Craig Altare
Supervising Engineering Geologist
California Department of Water Resources
901 P Street, Room 213
Sacramento, California 94236
Email: Craig.Altare@water.ca.gov
Portal Submission: <https://sgma.water.ca.gov/portal/#gsp>

May 15, 2020

RE: Eastern San Joaquin Groundwater Subbasin Groundwater Sustainability Plan prepared for the Eastern San Joaquin Groundwater Authority and dated November 2019

Figure 4-3: Proposed New Monitoring Well Locations (Shown in Orange)

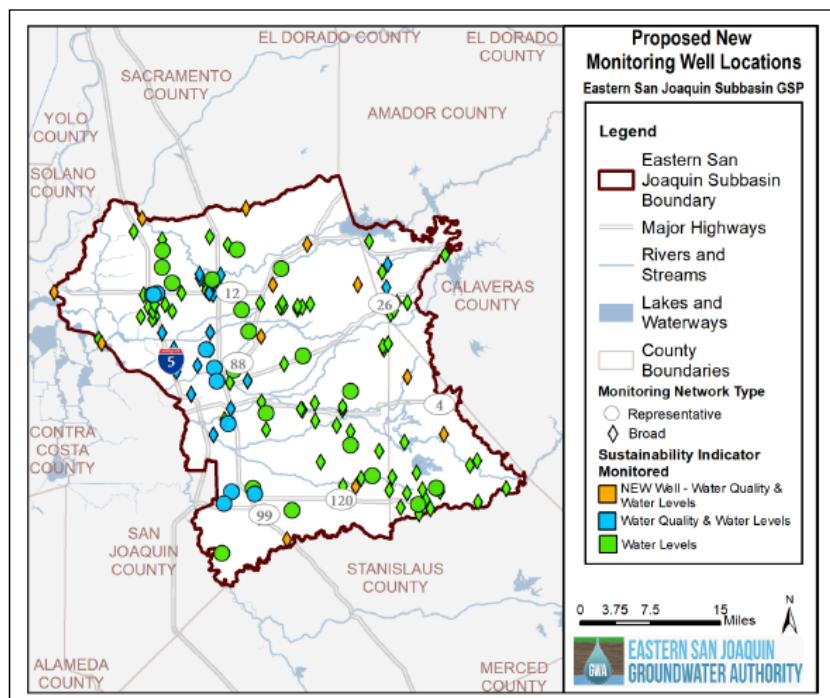
In addition to not having sufficient compliance wells to assess whether or not minimum thresholds are exceeded, 4 of 20 representative compliance wells (shown as circles in Figure 4-3) do not have construction details based on data reported in Table 4-1: Representative Monitoring Wells for Groundwater Levels. According to 23 CCR § 352.4 (2) If an Agency relies on wells that lack casing perforations, borehole depth, or total well depth information to monitor groundwater conditions as part of a Plan, the Agency shall describe a schedule for acquiring monitoring wells with the necessary information, or demonstrate to the Department that such information is not necessary to understand and manage groundwater in the basin. There are additional wells within the broader network that could have been identified as a representative monitoring well to manage the groundwater in the basin. Without additional representative wells management of groundwater conditions is hampered. The proposed new wells in the Final GSP are not intended to replace any of the representative monitoring wells that lack construction details but are proposed to increase understanding. Additionally, there are two of the representative monitoring wells used for compliance that are deeper than 700 feet with screened intervals up to 780 feet, complicating the apparent groundwater levels reported from these wells. What was the benefit of including these wells in the representative monitoring well set since these lengths are excessive and results in uncertainty as to the location of the source of water to the well?

There are up to 12 proposed new monitoring well sites (shown in Figure 4-3 in orange). There was no commitment to use these wells for compliance only that that the data will be used to increase understanding. Two of these wells will be deep, multi-completion wells, built using support awarded to the Subbasin by DWR’s TSS program. One of the TSS wells is located approximately in the middle of the northern Subbasin boundary (near Dry Creek) and the other well is located along Calaveras River near Highway 88 in the approximate middle of the Subbasin. Up to 10 of these wells are shallow and funded through the DWR Proposition 1 Sustainable Groundwater Planning Grant.

The proposed locations of these shallow wells were selected to be co-located with identified and potential groundwater dependent ecosystem (GDE) areas and near streams to further understand groundwater-surface water connectivity and to refine GDE data gaps. The Final GSP stated that “GDEs were ground-truthed with GSA staff and Groundwater Sustainability Workgroup (Workgroup) members”.

The Groundwater Sustainability Workgroup meeting was lightly attended when this activity occurred and a few members of the group shared their stories of some areas on several maps of the basin. Ground truthing is a term that usually involves checking map data in the field. There were no field visits that occurred, only personal observations. Through this process, areas identified as GDEs were discussed, and areas identified as irrigated were reclassified. These areas are labeled on Figure 2-74 as “Stakeholder Comment.” Those areas which were removed based on a single meeting of the Workgroup should be reconsidered given that many of the GDE areas that were removed in the draft have been included in the Final GSP and are under further investigation. Wells are allowed to be drilled within 150 feet of a surface water body and GDEs in these areas may be accessing both surface and groundwater. These GDEs may suffer if groundwater is unavailable due to decreasing groundwater levels through pumping more than recharging.

The Final GSP stated that in the Eastern San Joaquin Subbasin, representative wells were selected based on the history of recorded groundwater levels and potential to effectively represent the groundwater conditions. In addition to the 4 of 20 representative compliance wells (shown as circles in Figure 4-3) without construction details based on data reported in Table 4-1: Representative Monitoring Wells for Groundwater Levels, 3 of the 20 representative wells lack 20 years of monitoring data based on the hydrographs included in the Final GSP. One of these representative monitoring wells selected has less than approximately 5 years of data based on the

hydrograph included in the Final GSP. What is it about these wells that warranted their selection as a representative monitoring well used for determining whether or not actions to avoid undesirable effects are sufficient with such a short history of groundwater level data?

Figure 2-37: First Quarter 2017 Groundwater Elevation

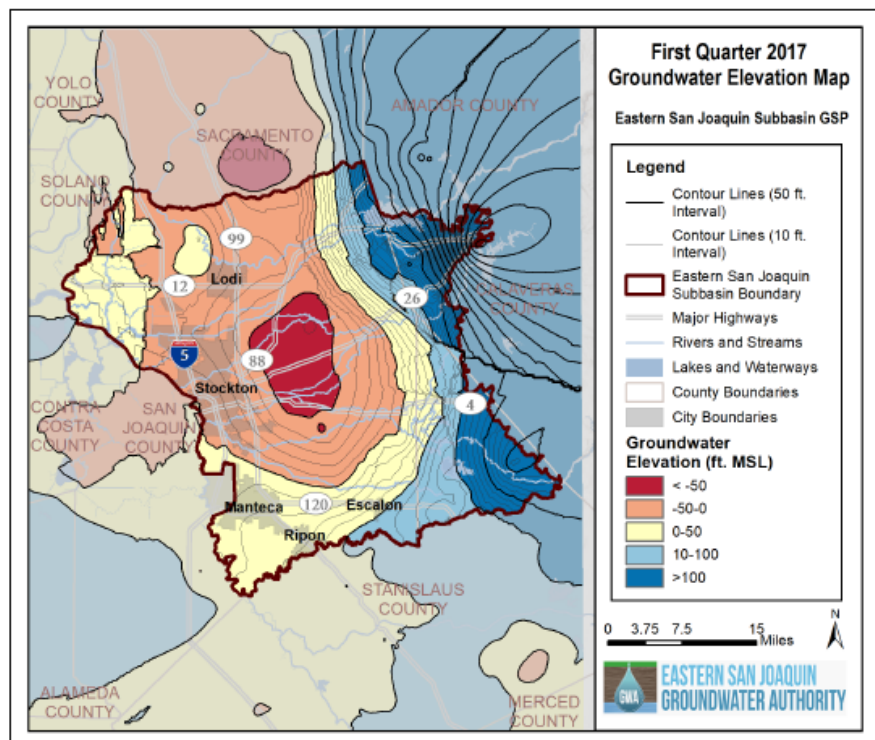
The adjacent figure from the Final GSP shows where the cone of depression - greatest groundwater overuse - is thought to be located. This figure leads to the impression that there is one large area in the Subbasin that is overdrafted.

These data suggest that the extent of overdrafted groundwater is more widespread and transient than depicted in the Final GSP. Additional representative monitoring wells and increased groundwater level monitoring data (quarterly) are needed to characterize the Subbasin and assess compliance with the minimum threshold criteria.

Figure 1. Change in Groundwater Elevation, Eastern San Joaquin Subbasin: Department of Water Resources Groundwater Information Center Interactive Map Application (A: ESJ Boundary; B: Change Spring 2004 – 2014; C: Change Fall 2006 – 2016; D: Change Spring 2008 – 2018)¹

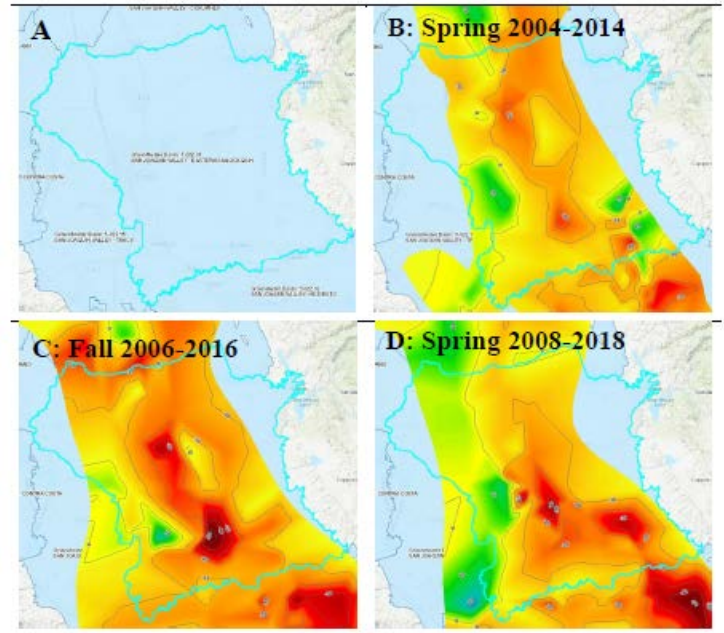
Larry Walker and Associates submitted comments including data from the DWR Groundwater Information Center Interactive Map Application (Figure 1) that shows the changes in groundwater elevation for three time periods: B: Spring 2004-2014, C: Fall 2006-2016, and D: Spring 2008-2018.

Dark red represents 40 feet of decline, orange represents 20 feet of decline, green represents 10 feet of increase).

As shown, during the period spring 2004-2014 (Map B) groundwater levels declined 20 feet in the south-central portion of the Subbasin, while during the period spring 2008-2018 (Map D), groundwater levels declined up to 40 feet in the southern portion of the Subbasin.

DWR Domestic Well Counts¹

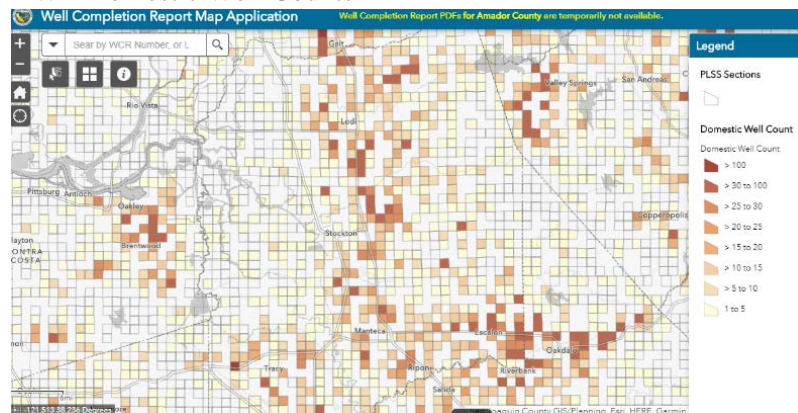
The DWR well log database domestic well counts are also shown below with the darker colors showing the higher density of domestic wells. The Final GSP stated that there are approximately 10,000 domestic wells within the Subbasin. The loss of a domestic well usually results in a loss of water for consumption, cooking, and sanitary purposes, which can often have substantial impacts on the users of the water and can be financially difficult for the well owner to replace. This hardship will be overly experienced by the lower income residents that rely on private domestic wells or small public water systems dependent on groundwater. Areas of high disadvantaged populations are shown on the community water system map. In order that the groundwater level monitoring network capture a greater area where these wells are located, additional representative monitoring wells are needed to ensure that these shallower wells are protected. Additional representative monitoring wells are needed to establish triggers in these areas so that appropriate responses can be initiated before groundwater levels decline due to ineffective GSP implementation measures or droughts relating to climate change.

Figure 6-10. Illustration of conceptual ground water source area and protection zones (Adapted from Witten and Horsley, 1995)

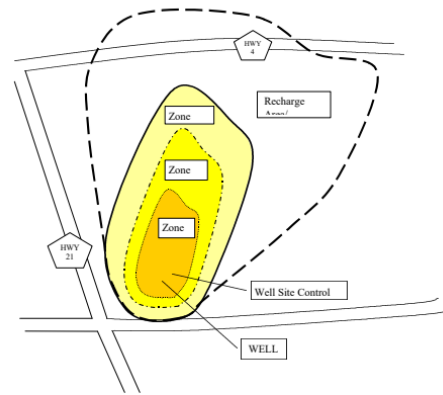
The adjacent figure from the Source Water Assessment Program guidance illustrates the non-point nature of groundwater wells². The notion that groundwater movement is restricted to property boundaries must be eliminated if the Subbasin is to achieve sustainability while protecting the shallower wells within the Subbasin. Some non-regulatory measures that have been shown to be effective to protect sources of drinking water and does not require any new ordinance or regulations and should have been considered as part of wellhead protection measures include:

Domestic Well Minimum Depth

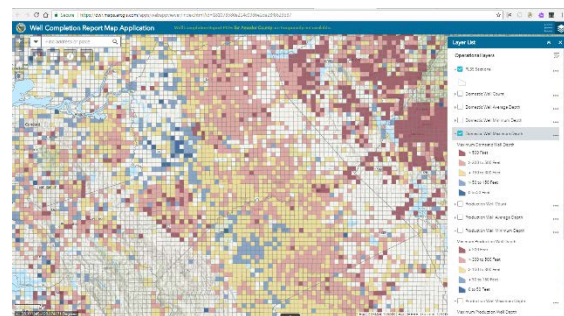
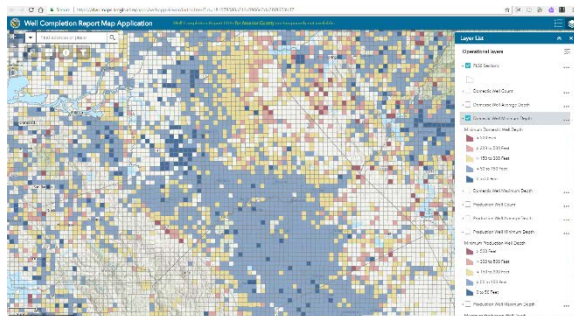
The following figures were obtained from the DWR Groundwater Well Log database referenced earlier and shows the distribution of domestic well minimum and maximum depths. Domestic wells with minimum depths of 50 and 200 feet appear most frequent (light blue and tan) corresponding to maximum depths of 150 to 500 feet (tan and rose), respectively.

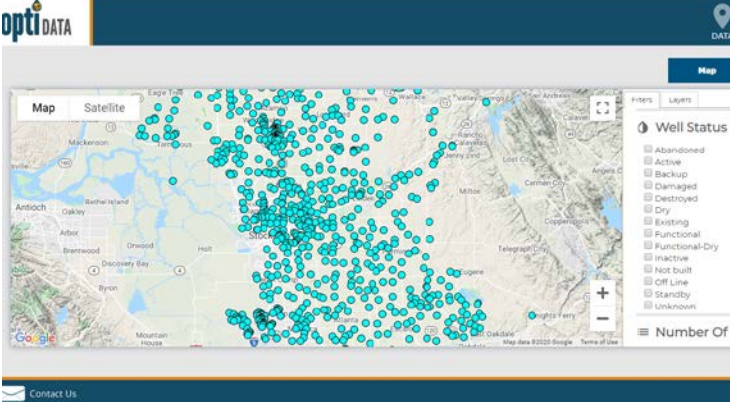
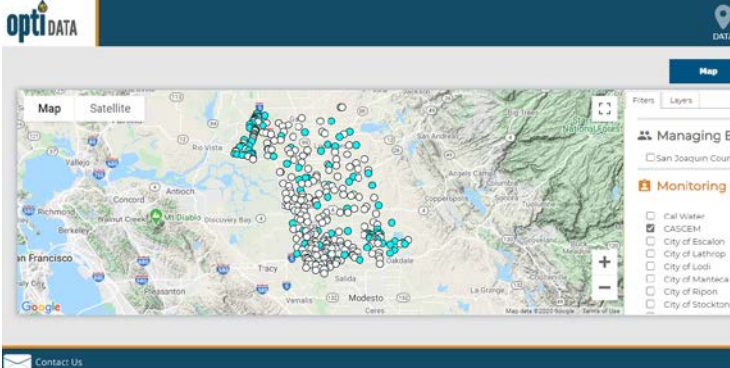
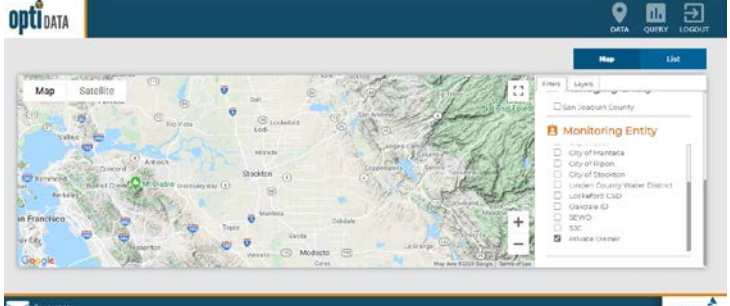
The use of a 100 percent buffer of historical range is excessive and puts shallower domestic and small public water systems wells at greater risk of dewatering by creating a minimum threshold which if achieved would result in many wells affected. The hydrographs included in Appendix 3A are illustrative of this point. Three examples are shown below from the Final GSP.

Those hydrographs of the representative monitoring wells (3 are shown above) provide a comparison of well levels during the droughts of 1992, 2015, and 2016 and the range between measurable objectives and minimum thresholds during significant drought periods. If minimum thresholds were achieved at the extent specified by the GWA and GSAs within the Subbasin, there will not be enough money to fix to the problem. Better that minimum thresholds are higher (that is higher groundwater levels) so that if an exceedance did occur the impacts on domestic well and small public systems and surface water uses could be mitigated with immediate demand reductions – an emergency situation. Waiting for two years before initiating a response relating to an undesirable result is not justified other than the GWA and associated GSAs did not think the situation was unreasonable. Given that the representative monitoring well density is low 1.7 wells/100 square miles a very large area would be impacted before “at least 25 percent of representative monitoring wells: used to monitor groundwater levels (5 of 20 wells in the Subbasin) fall below their minimum level thresholds for two consecutive years that are categorized as non-dry years (below-normal, above-normal, or wet). There is no justification for the “at least 25 percent” other than the GWA and associated GSAs did not think that large area of impact was unreasonable. This is not protective or proactive.

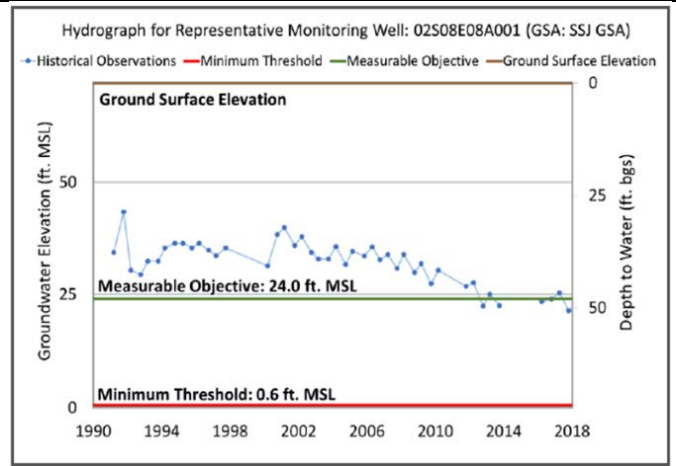
This is the example hydrograph of a representative well's data included in the Final GSP. This referenced well: 02S08E08A001 was used to check if the required well criteria was available for the public.

There is no ability to filter or query the representative wells. As filtering by representative well is not possible, the well ID was used in my browser to locate the well in the well list.

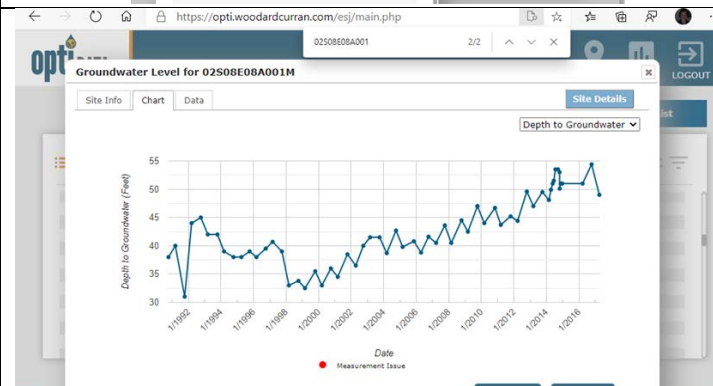
There is no well construction information in the database for this example representative well.

This hydrograph looks different from the example hydrograph referenced above. The reason is that the example in the Final GSP starts at 0 feet depth to water (below ground surface) which is a typical way that groundwater elevation is illustrated, whereas the database hydrographs start at 55 feet. This presentation at first glance appears that the groundwater elevation is increasing. Data after 2017 is not in the database. GSAs need to update the database with any well construction details and contemporary groundwater data.

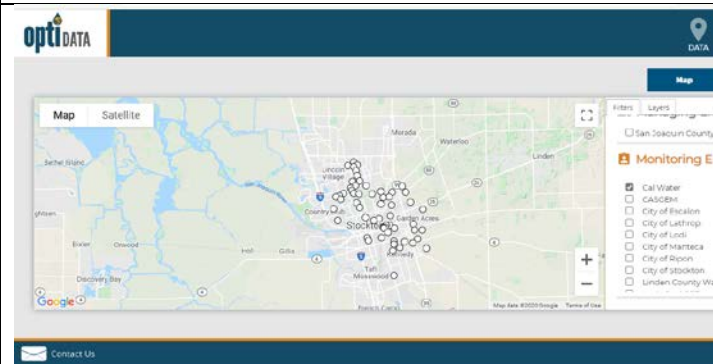
Cal Water wells within the City of Stockton GSA are indistinguishable from wells within the San Joaquin County GSA #2.

Figure 49a: ESJWRM Groundwater Budget - Eastern San Joaquin Subbasin

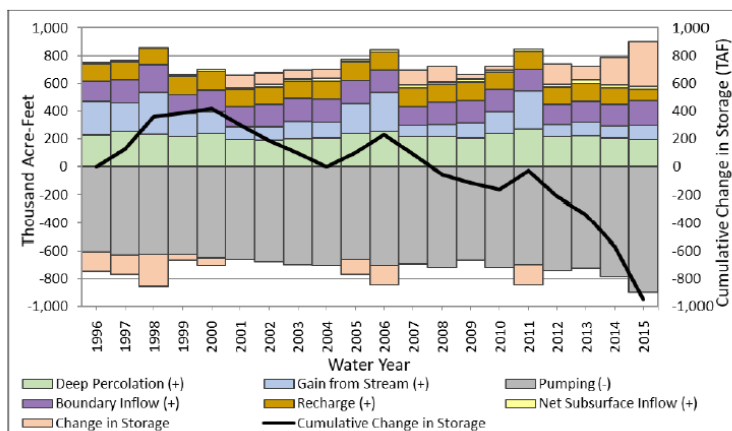
The model derived groundwater budget (above) from the Final GSP shows deep percolation in green bands and recharge in tiny tan bands.

Figure 2-14: Potential Recharge Areas

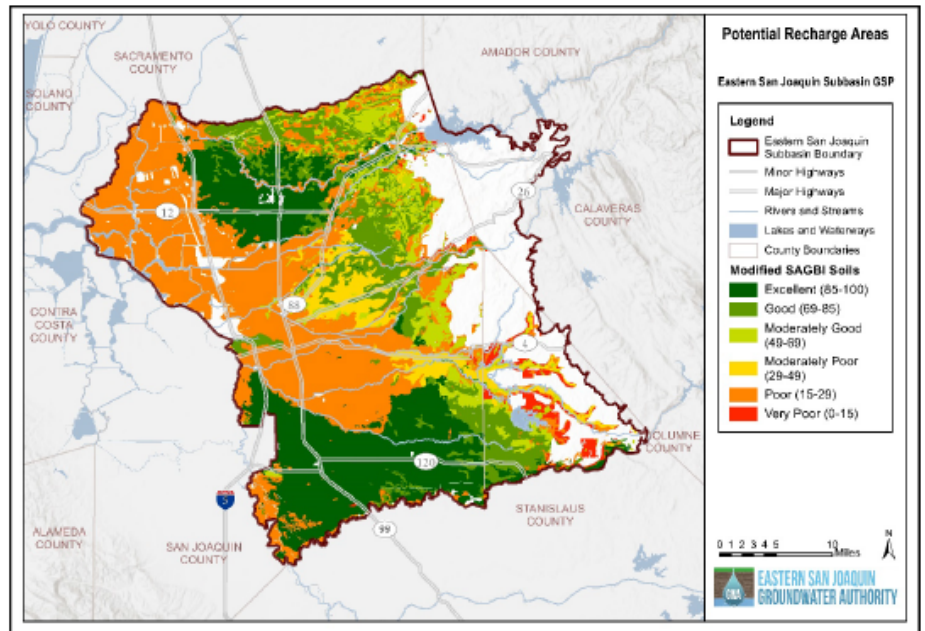
The Final GSP used the Groundwater Banking Index (SAGBI) to prepare the required map showing recharge areas in the Subbasin. SAGBI provides an index for the groundwater recharge for agricultural lands by considering deep percolation, root zone residence time, topography, chemical limitations, and soil surface condition. The Modified SAGBI data assumes that the soils have been or will be ripped to a depth of 6 feet, which can break up fine grained materials at the surface to improve percolation. The final GSP stated that the Modified SAGBI data categorizes 310,098 acres out of 610,890 acres (51 percent) of agricultural and grazing land within the Subbasin as moderately good, good, or excellent for groundwater recharge (University of California, Davis, 2018).

The model included the figure below of soil groups relating to percolation potential. As both maps indicate some areas may be of greater benefit; therefore, additional refinement is needed so that these areas identified as having the best potential for recharge can be set aside and designated for that land use. No specific areas were identified where land use protections should be established to protect this resource. Without more detailed information these areas may have reduced value in the future due to competing land uses.

November 13, 2018 Groundwater Sustainability Workgroup slides

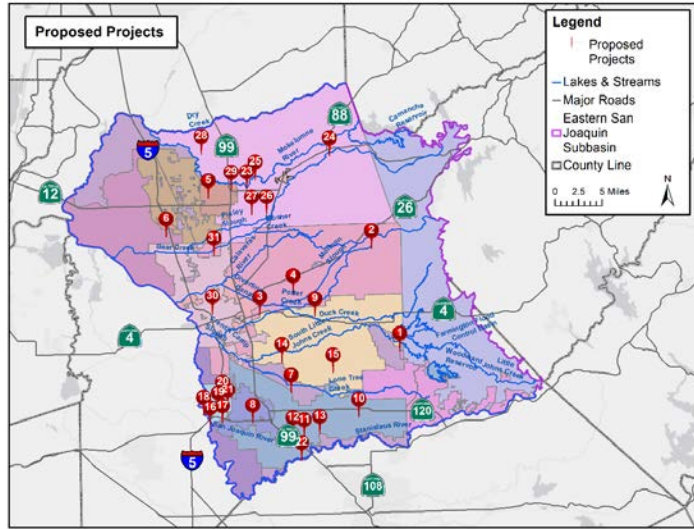
The initial 31 Projects shown in the figure from Workgroup slides became 23 in the Draft and Final GSP. Six of the 31 projects were sponsored by the City of Lathrop which left the Eastern San Joaquin Subbasin to join the Tracy Subbasin. The Oct 10, 2018 GWA Advisory Committee meeting slides noted that highlighted projects were included in the baseline assumptions for modeling. As of October 10, 2018, there were 22 projects considered and of these there were 8 of projects included in the baseline assumptions. No document where the baseline projects were listed or characterized was located. It seems as if the project included as part of the model baseline should not be included as planed project to improve groundwater elevations.

Figure 19a: ESJWRM Annual Cropping Pattern – Eastern San Joaquin Subbasin

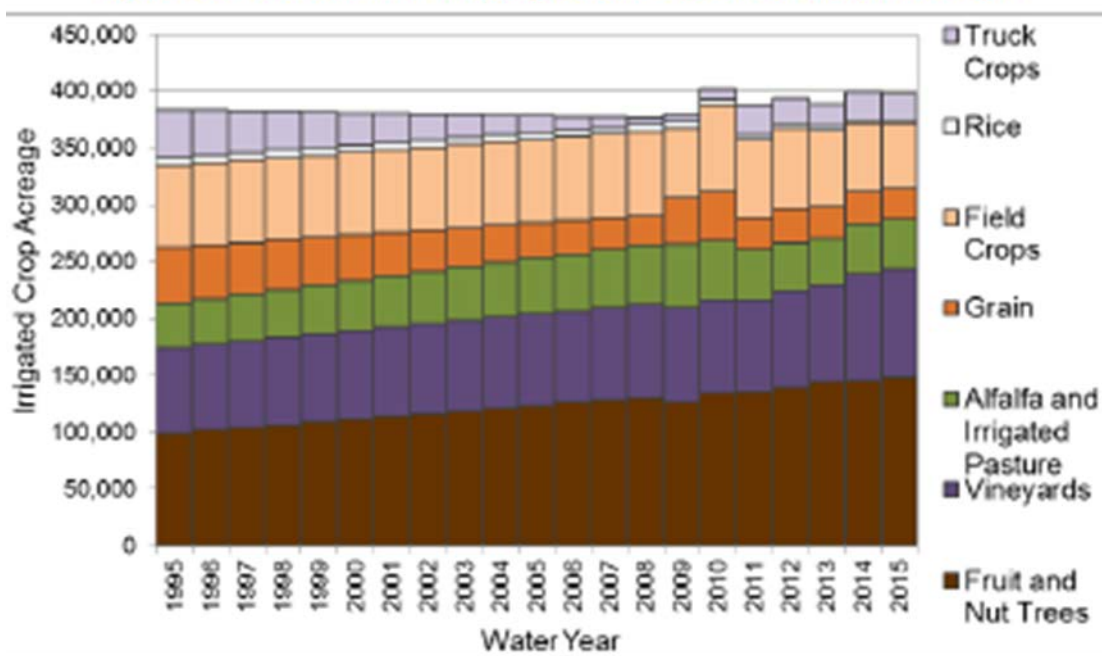
The model budget showed increased groundwater pumping and increased permanent crop acreage through 2015. This trend has continued where field crops are converted to orchards with higher water demand and various areas of the Subbasin undergoing urbanization with significantly different costs for water throughout the Subbasin.
